**ADDENDUM #2**

To: All Bidders  
Project Name: Renovations to:  
GVSD District Administration Office  
100 Lindenwood Drive, Malvern, PA 19355  
Prepared for: Great Valley School District  
301 Lindenwood Drive  
Malvern, PA 19355  
Date: January 11, 2023

Notice to all Contractors bidding the Renovations to the GVSD District Administration Office. This Addendum is to amend or clarify the Contract documents as follows:

**E101**

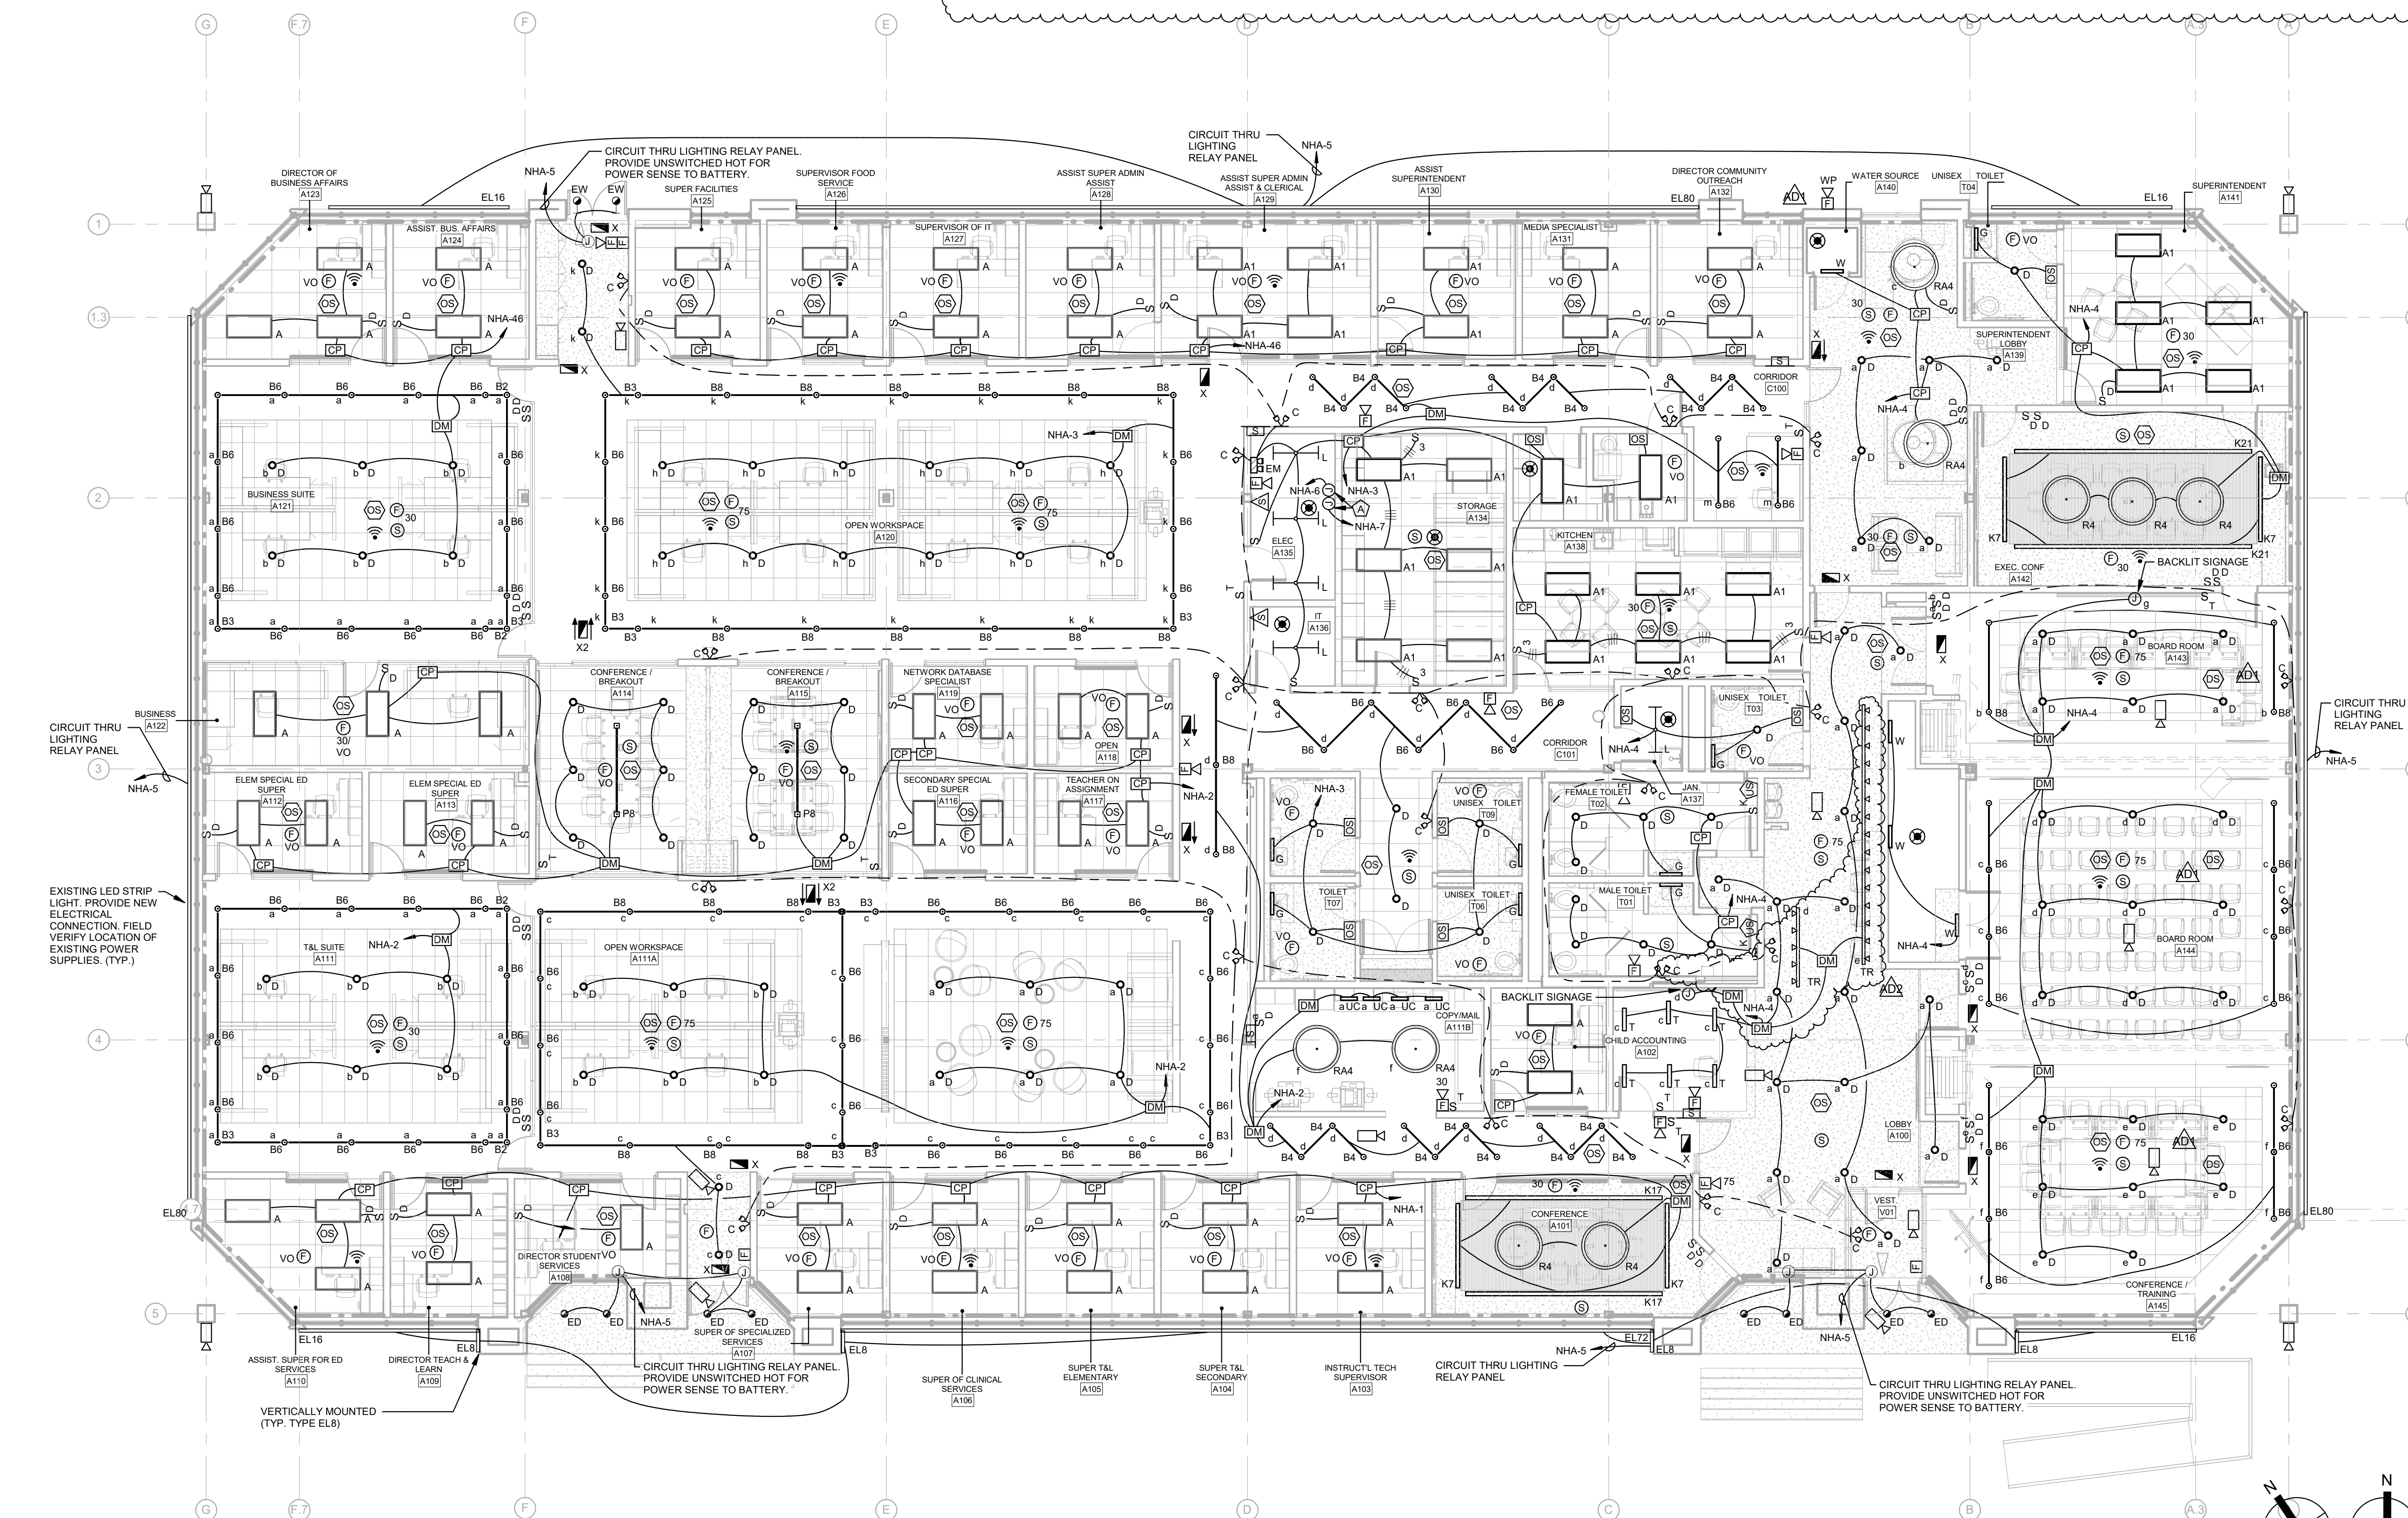
- 2.09 Drawing E101: **REVISE** lighting fixture schedule. See attached. **ADD** track lighting in main lobby. Circuit as separate zone with local lighting controls.
- 2.10 Drawing E201: **REVISE** electrical device locations in kitchen to match Architectural plans.
- 2.11 Drawing E202: **ADD** electrical connection for exhaust fan EF-3. Circuit to NLA-63.

**1 | FIRST FLOOR PLAN - MECHANICAL**

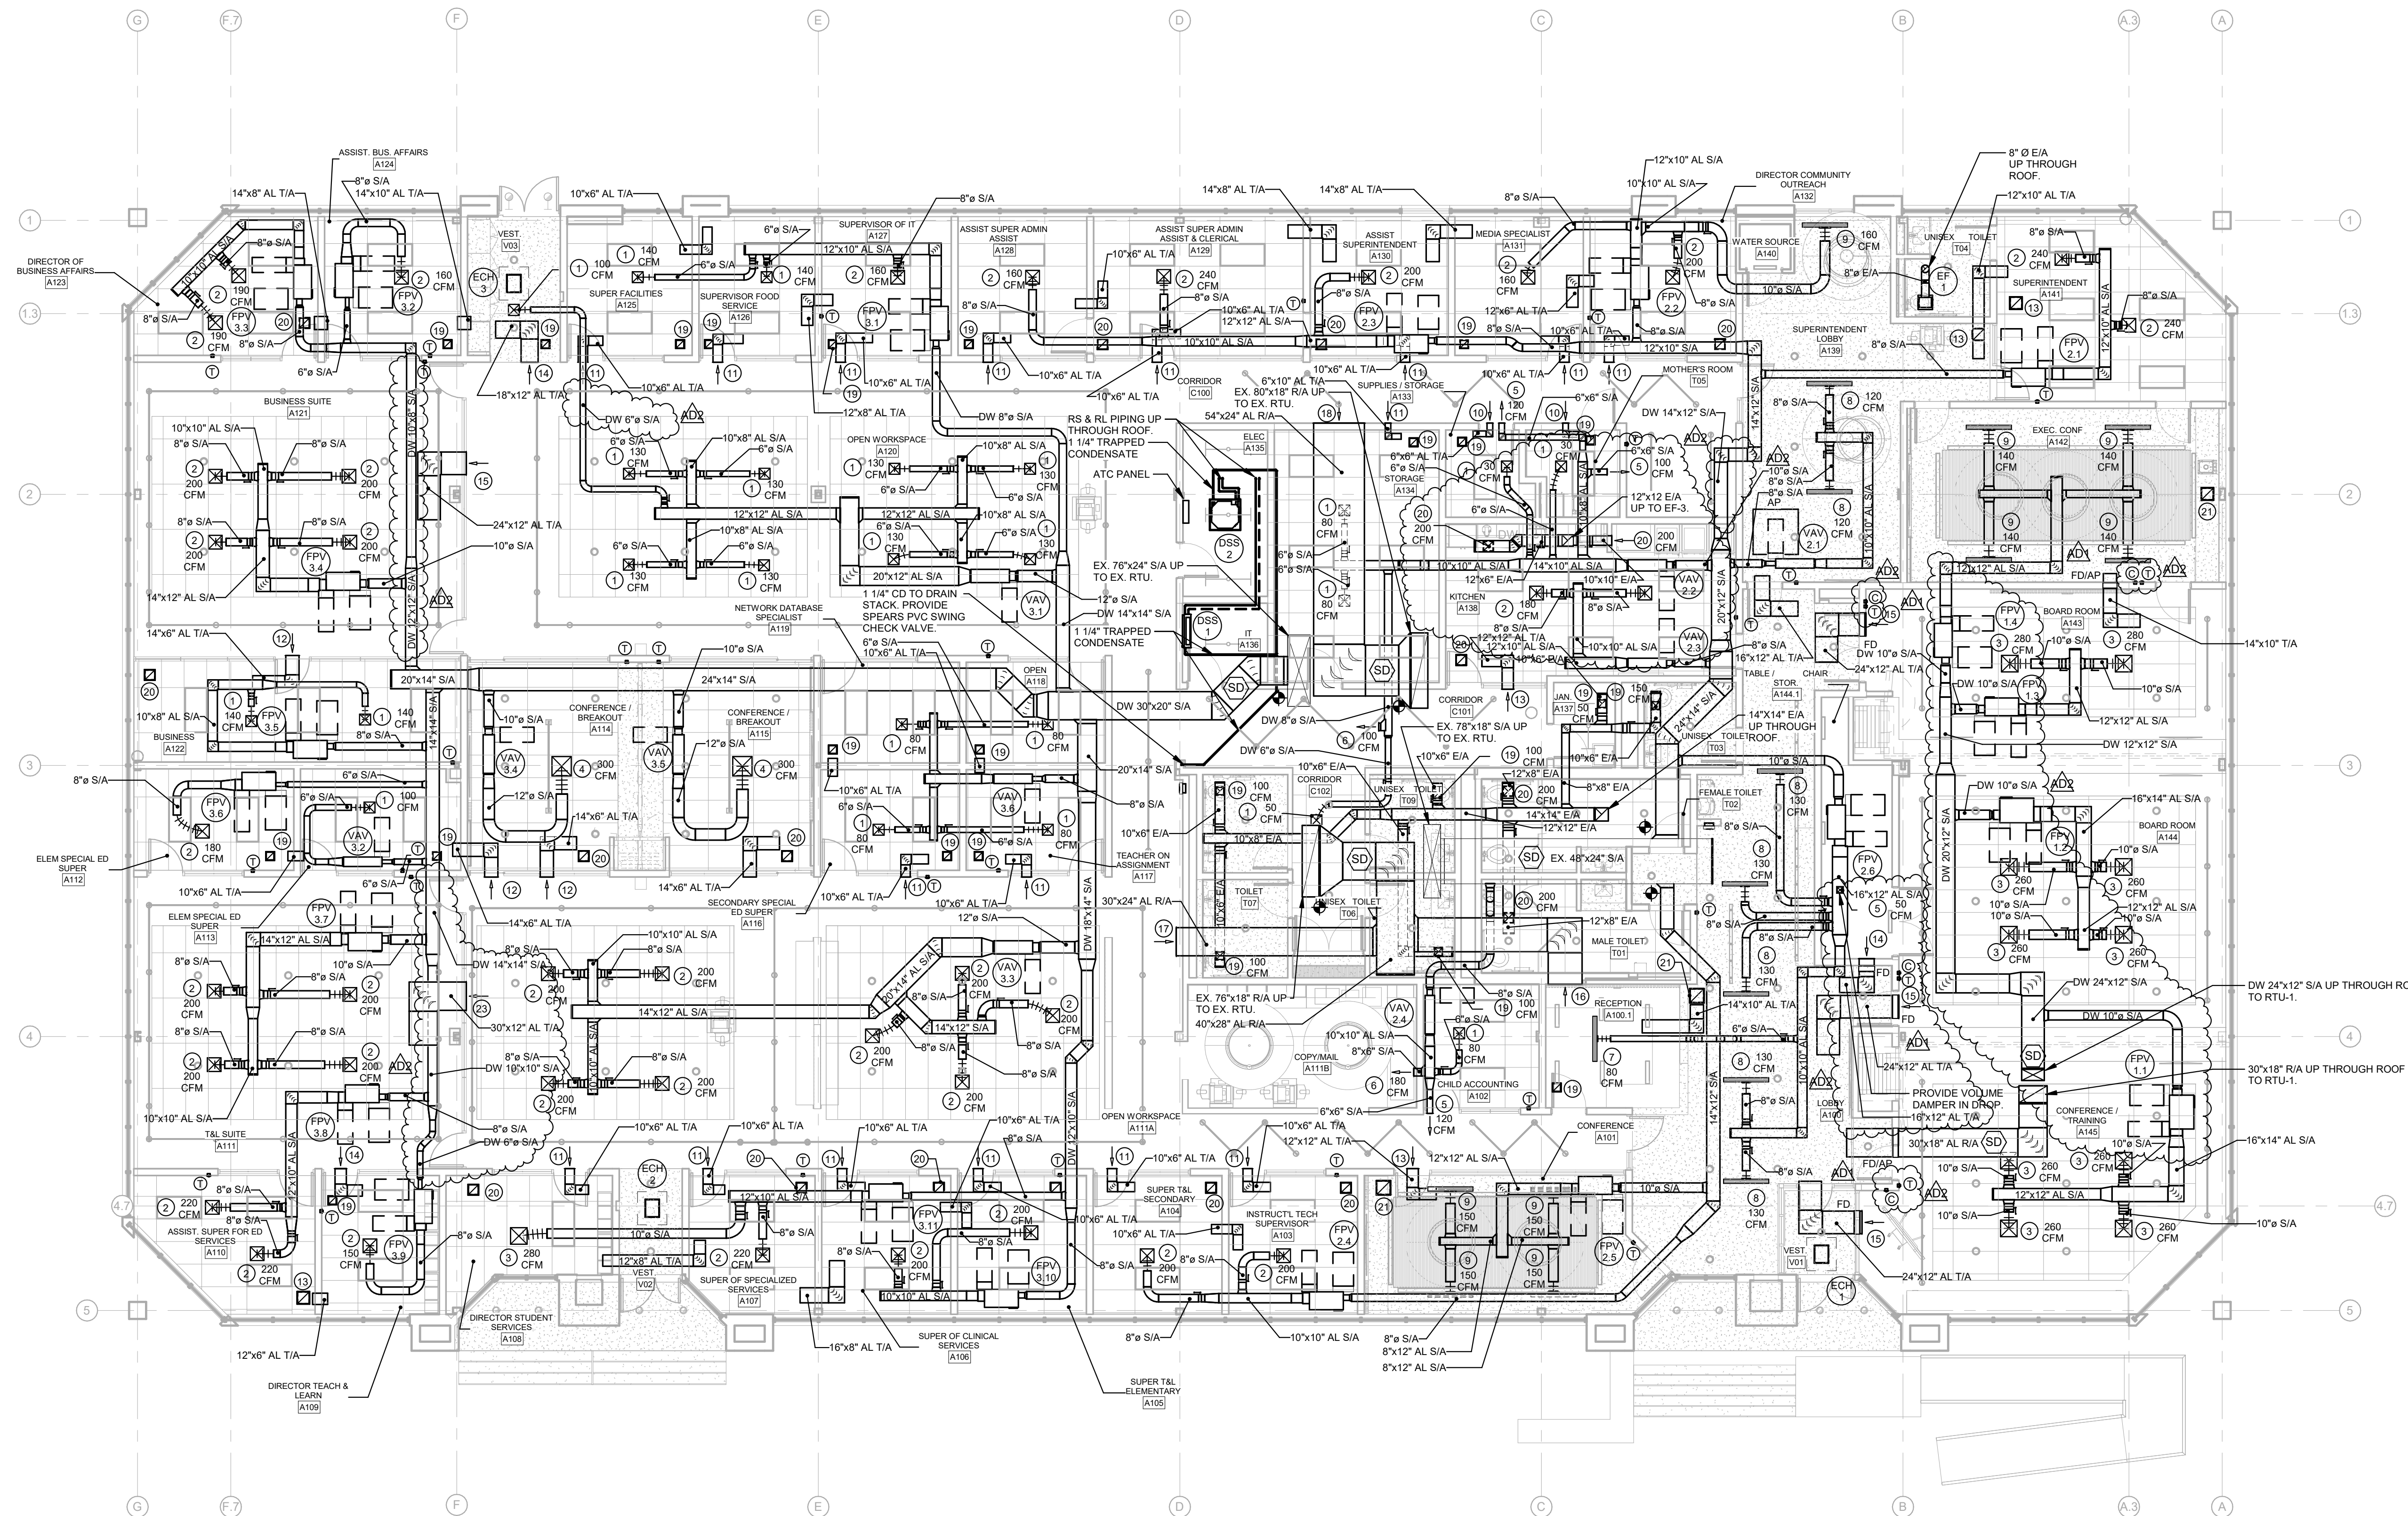
- 2.13 Drawing M100; **ADDED** exhaust fan EF-3 and associated ductwork. Refer to revised drawing.

- 2.14 Drawing M100: **REVISED** duct type in several exposed instances to double-wall. Refer to revised drawing.
- 2.15 Drawing M100: **REVISED** location of several GRD in Kitchen A138 and Mother's Room T05 to coordinate with ceiling grid orientation. Refer to revised drawing.

- 2.16 Drawing M100: **REVISED** location of FPV-1.1, 1.2, 1.3 to conceal units above ceiling clouds. Refer to revised drawing.
- 2.17 Drawing M100: **ADDED** duct tag for first diffuser downstream of FPV-2.6. Tag shall be #5 at 50 CFM. Refer to revised drawing.

- 2.18 Drawing M100: **REVISED** transfer air grille and duct associated with Table/Chair Storage A144.1. Refer to revised drawing.
- 2.19 Drawing M100: **ADDED** Carbon Dioxide sensors (adjacent to thermostats) in Conference/Training A145, Board Room A144, Board Room A143, and Executive Conference Room A142.
